SUBJECT: TECHNICAL BASIS FOR REVISED REGULATORY GUIDE 1.183
(DG-1199) FISSION PRODUCT FUEL-TO-CLADDING GAP INVENTORY

Proposed Revisions DG-1199

Revised Section 3.2

Figure 1 Maximum Allowable Power Operating Envelope for Non-LOCA Gap Fractions

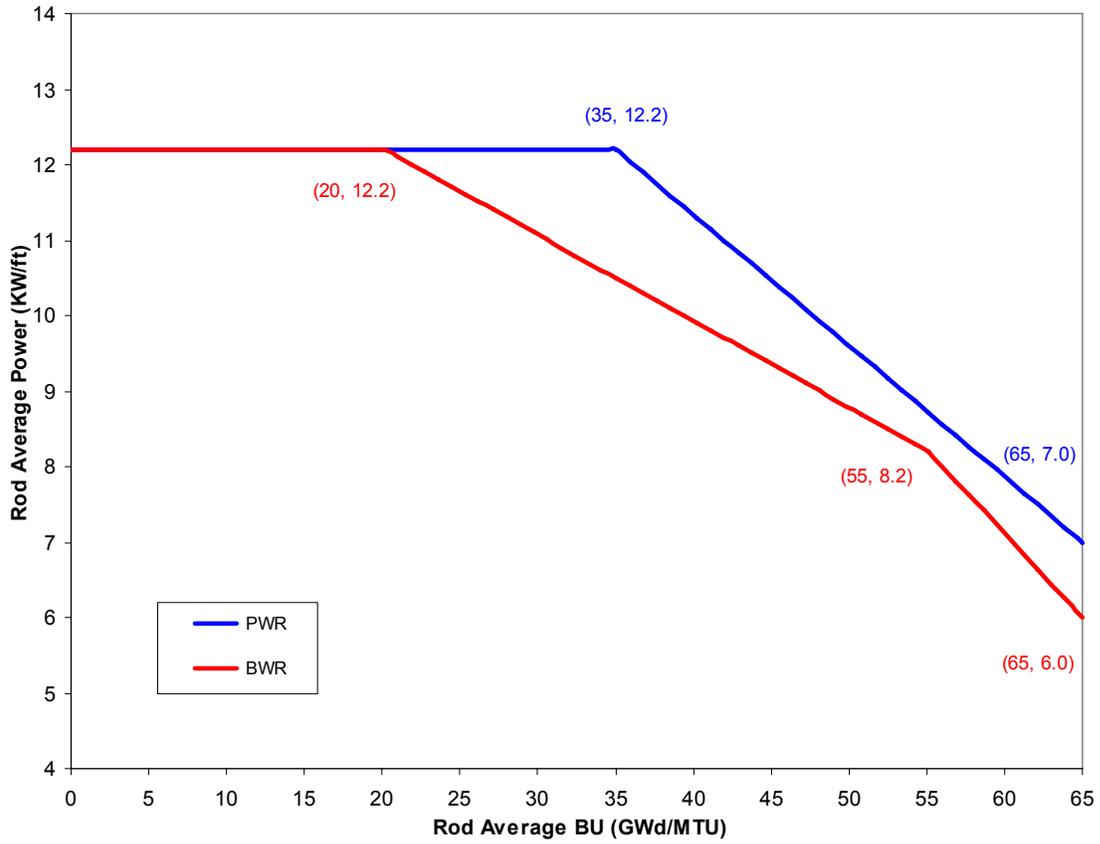
- In response to public comment, bounding fuel rod power profiles were extended. This necessitated a re-calculation of the fission product gap inventories. As part of this effort, peak nodal power (F_q) was replaced with rod average power (F_r) which is a better qualifier for fission gas release along the entire fuel stack and overall gap inventory.

The applicability of Table 3 non-LOCA fission product gap fractions is limited to fuel rods with a peak rod average power history below the bounding power envelope depicted in Figure 1. Appendix K provides an acceptable analytical technique for calculating non-LOCA fission product gap inventories based upon specific fuel rod designs or more realistic fuel rod power histories. Reference 18 documents the methods used to calculate the Table 3 and Table 4 fission product inventories, including application of modeling uncertainties.
